APPLICATION NO.	FILING DATE	FIRST NAMED INVENTOR	ATTORNEY DOCKET NO.	CONFIRMATION NO.
10/642,708	08/18/2003	Jason Werning	35650	4369
116 7590 01/29/2007 PEARNE & GORDON LLP 1801 EAST 9TH STREET SUITE 1200 CLEVELAND, OH 44114-3108			EXAMINER GLUCHOWSKI, KRISTINA R	
			ART UNIT	PAPER NUMBER
			3676

Office Action Summary

DETAILED ACTION

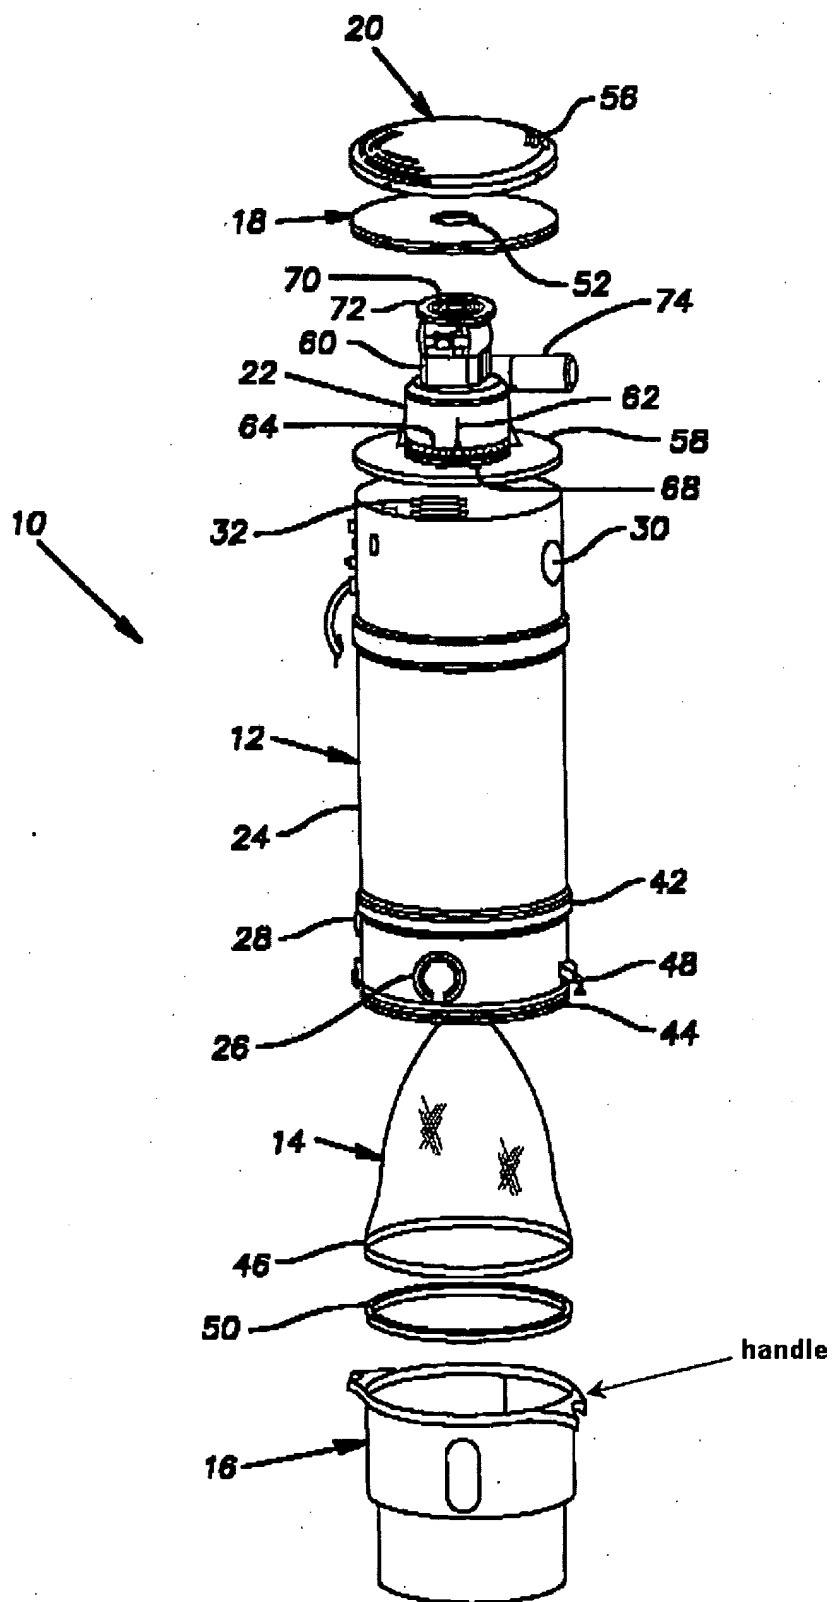
7. Claims 1, 5, 8 and 19-21 are rejected under 35 U.S.C. 102(b) as being anticipated by Fritz et al (US 5813085). Regarding claims 1, 19 and 21, Fritz shows a locking mechanism for a central vacuum system comprising a twist-lock latch (48) configured to receive a handle (see illustration below) of a debris receptacle (16), and a vertical gasket (50) to facilitate an airtight seal between the debris receptacle and a canister (12) of the central vacuum system. The examiner would like to note that a "twist-lock latch" could be any latch. The term "twist-lock" is considered a label in claim 1 since no further structure of the twist lock latch is claimed.

9. Regarding claim 8, the vertical gasket includes a bead roll (see illustration below; lower portion of gasket), the diameter of the bead roll corresponding with a groove (44) formed in an exterior surface of the canister (column 3, lines 30-32).

10. Regarding claim 20, Fritz shows two latches (48) on opposing sides of the canister (see figure 1). See the Fritz device below.

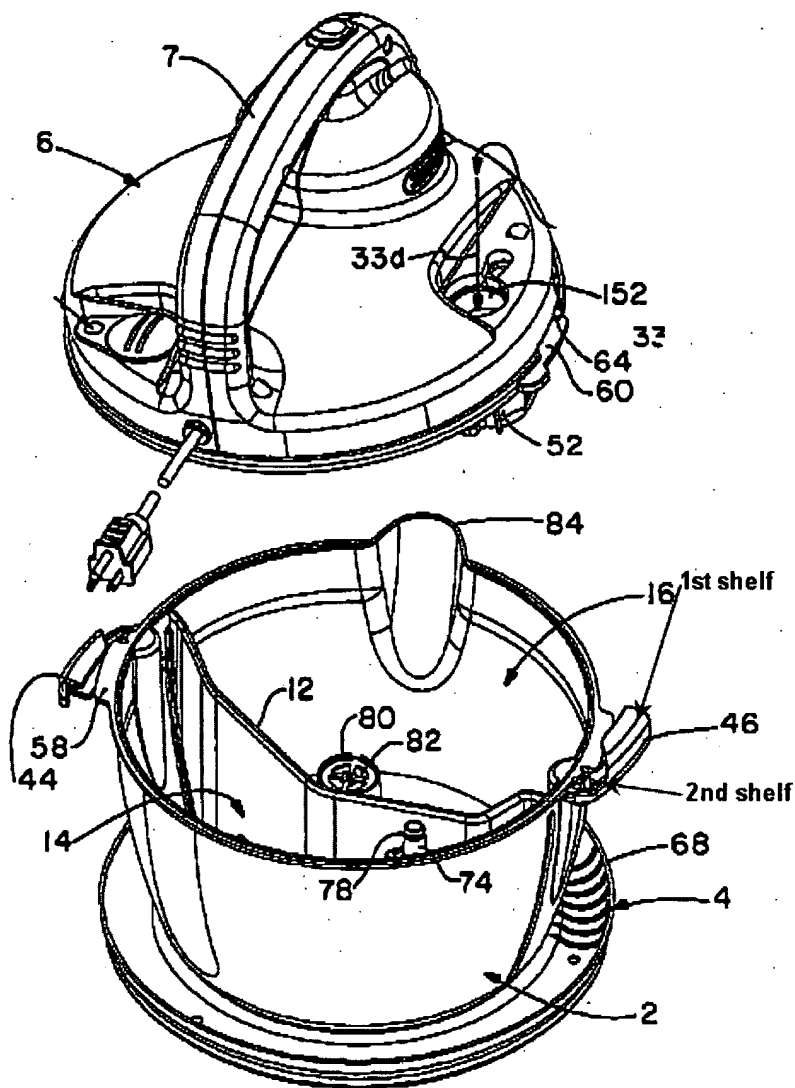
11. Claims 9, 11 and 13 are rejected under 35 U.S.C. 102(b) as being anticipated by Schwartz (US 4279355). Regarding claim 9, Schwartz shows a twist-lock latch comprising a first shelf portion (see illustration below) and a stop detent (see illustration below). The examiner would like to note that "for use in a locking mechanism of a central vacuum system" does not positively claim the combination of the twist-lock latch and the vacuum. "For use" is merely intended use of the structurally claimed apparatus. The claimed structural limitations are met and therefore Schwartz discloses the claimed invention.

12. Regarding claim 11, Schwartz shows a contoured ramp configured to guide the handle into place (see illustration below).

13. Regarding claim 13, the twist-lock latch has no moving parts. See the Schwartz device below.

17. Regarding claim 2, Schwartz shows a twist-lock latch mechanism comprising a handle portion (24) and a contoured ramp (see illustration above) to guide the handle portion into place. Regarding claim 3, the twist-lock latch of Schwartz comprises a stop detent (see illustration above, edge of groove 40). Regarding claim 4, the twist-lock latch of Schwartz does not include moving parts. It would have been obvious to one of ordinary skill in the art to replace the Fritz latch with the latch of Schwartz since it is considered to be within the level of ordinary skill to exchange one latching means for another. Both latching means accomplish sealing a top portion to a canister. Replacing the Fritz latch with the Schwartz latch would increase ease of use for the device in that the latching and unlatching motion would be reduced to a simple rotation as opposed to holding the canister in place and snapping each latch separately.
